ADDENDUM #5

Reference: Noorda Black Box Theater Addition and Remodel
Utah Valley University – Orem, Utah
DFCM Project No. 08017790

ADDENDUM - 5

Project: UVU Noorda Theater
DFCM Project Number: 08017790
Axis Project Number: 0804
To: Mike Ambre
From: Axis Architects
Date: August 16, 2008

8
 SCALE: 3/4" = 1'-0" SE302

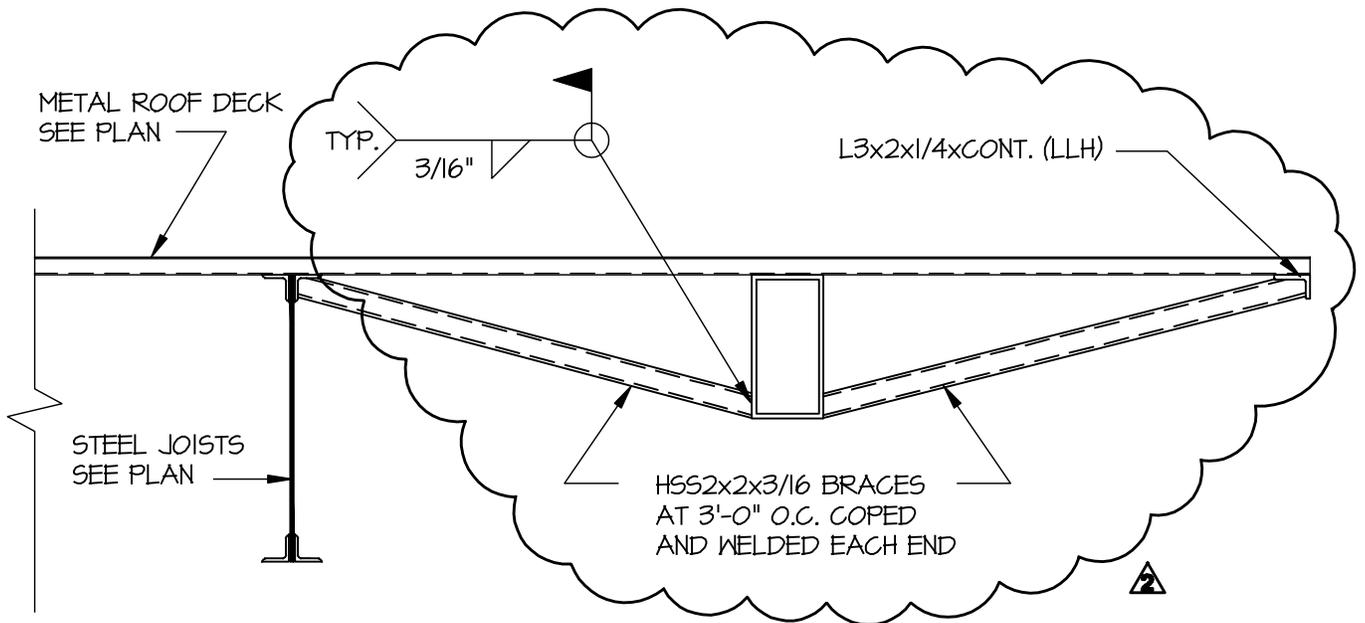
1. The masonry wall in detail 1, 2, and 3/SE302 shall be 12" thick with brick veneer anchored as per the typical details.
2. See revised detail 8/SE302.

SCALE: 3/4" = 1'-0" SE303

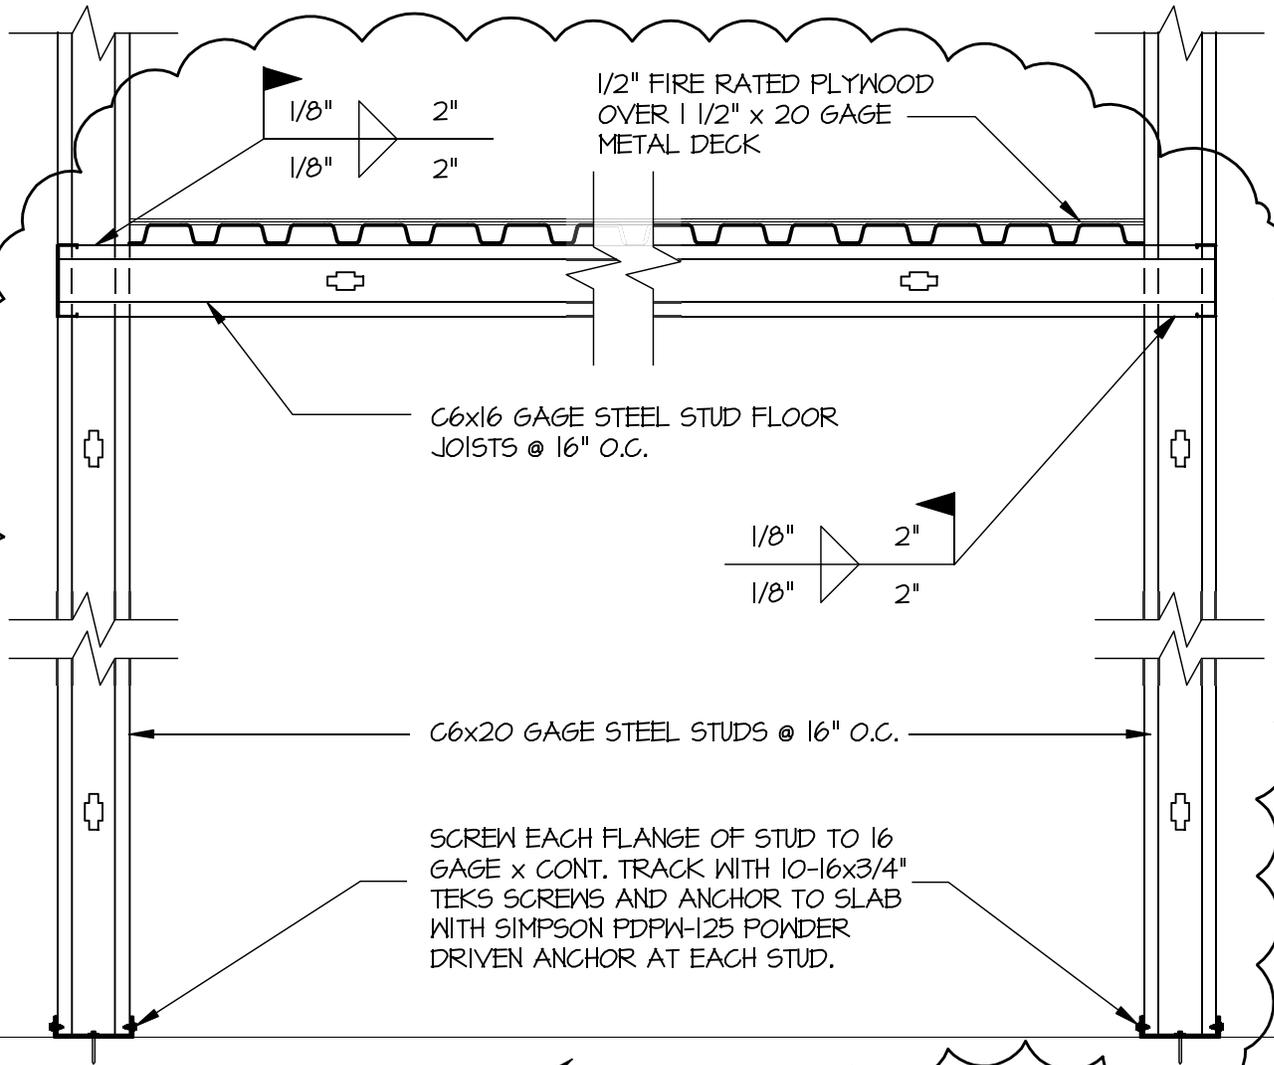
1. See revised details 8/SE303 and 9/SE303.

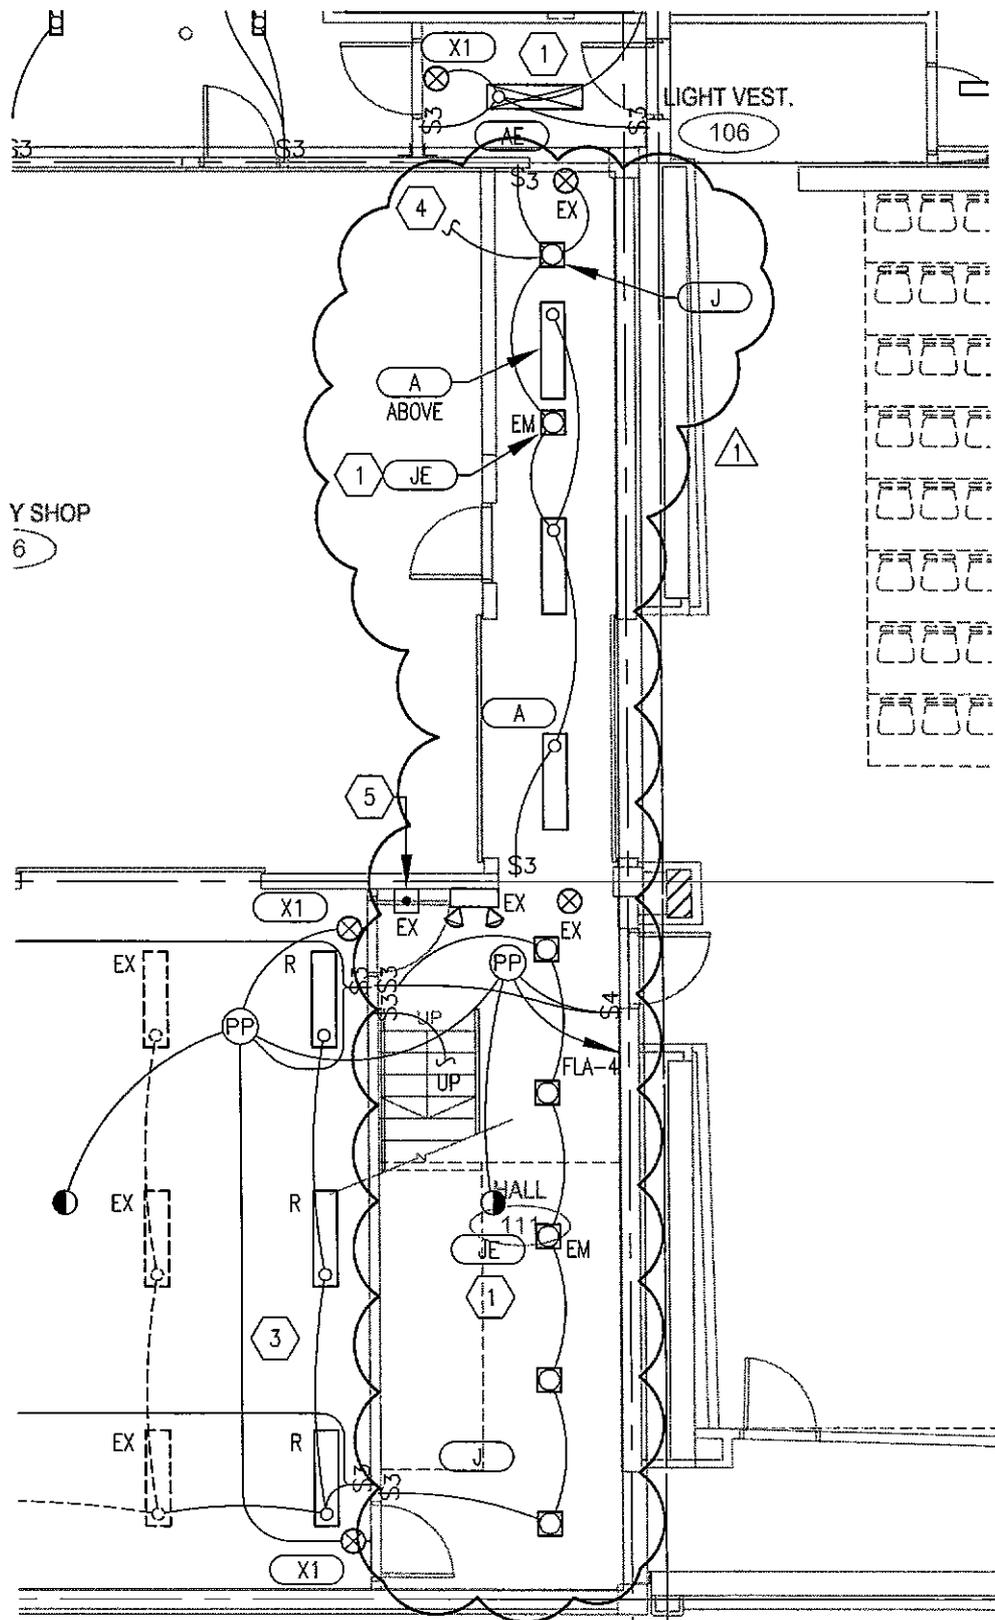
1. White Box Room 131. Delete the (5) new fixture type C4 fixtures shown. Reuse the existing 2 x 4 lay-in fixtures and relocate per attached revised drawing. Relocate the three room light switches to the north adjacent to the new door into the White Box. Provide new switches and occupancy sensors in White Box Office and White Box Audience room and provide new switch legs as required. Provide (2) additional Type E recessed cans and dimmer switch in White Box Office. Provide (2) 12 tracks with (10) track heads and (2) new incandescent dimmer switches in White Box 131. See attached revised drawing.

A2 LEVEL 1 EXITING PLAN
SCALE: 1/16"=1'-0"

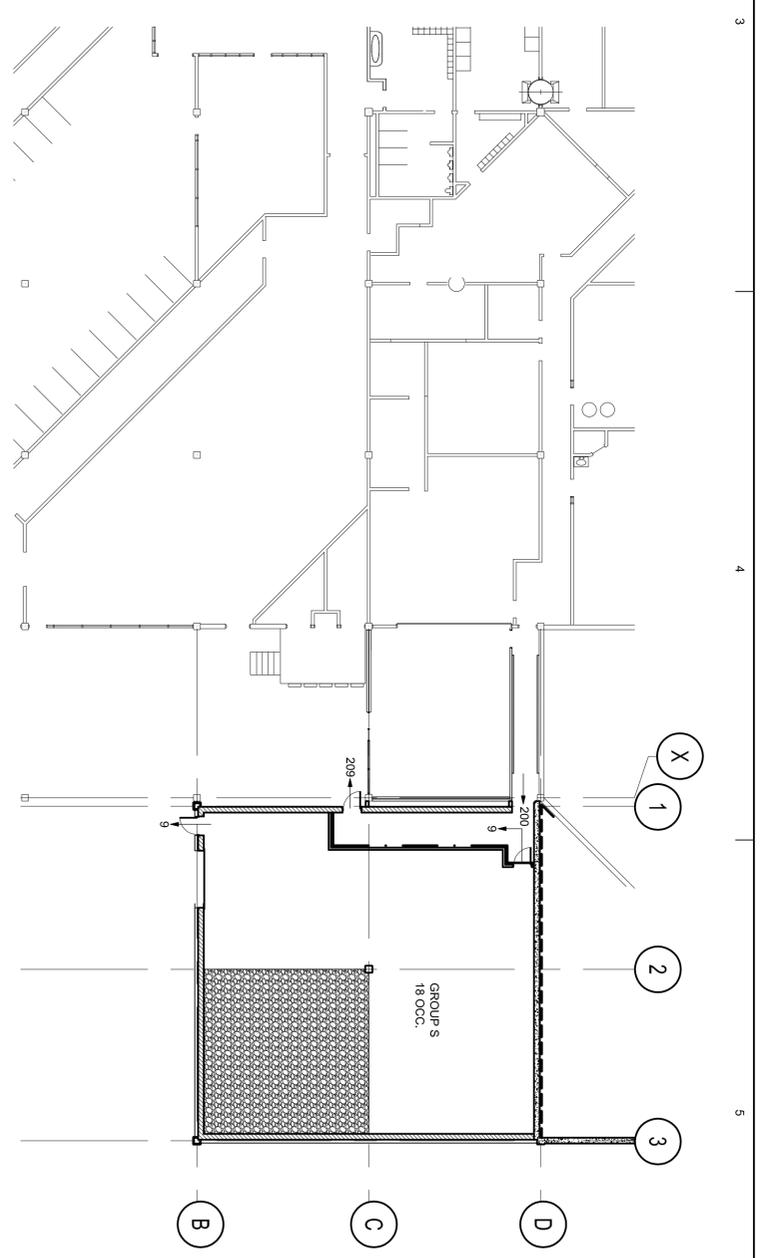
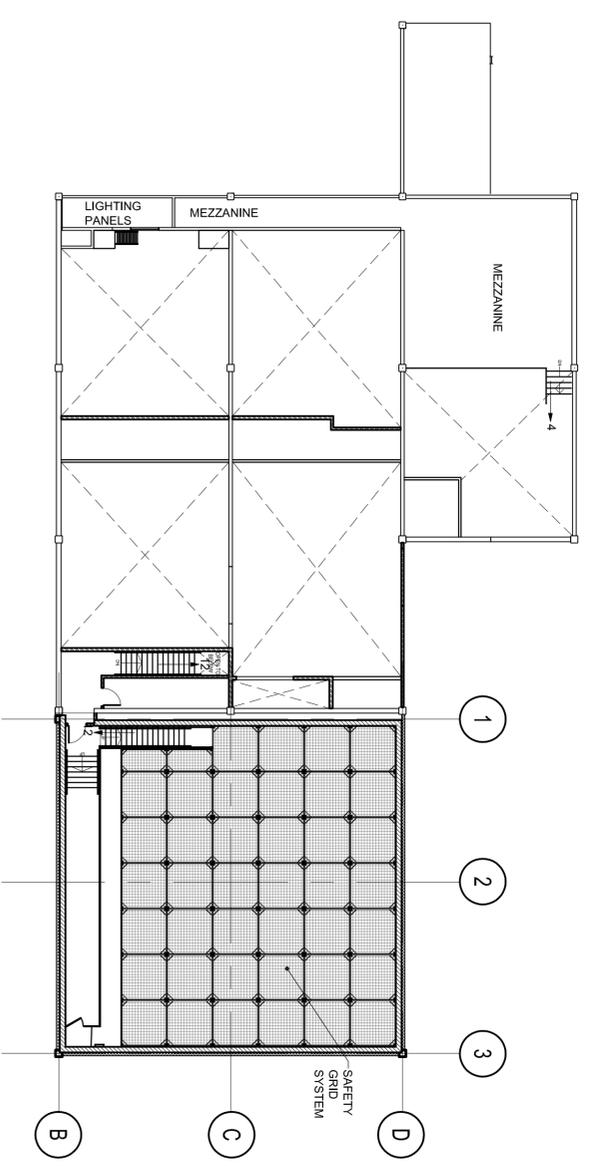
- Sheet AE101:** - The walls on grid 1 shall be 1hour rated. See GI102.
 - Eliminate doors 108C and 108D.
 The following doors shall be 20mn fire rated:
 108A, 108B, 106C, 108E110A, 112A, 113A.
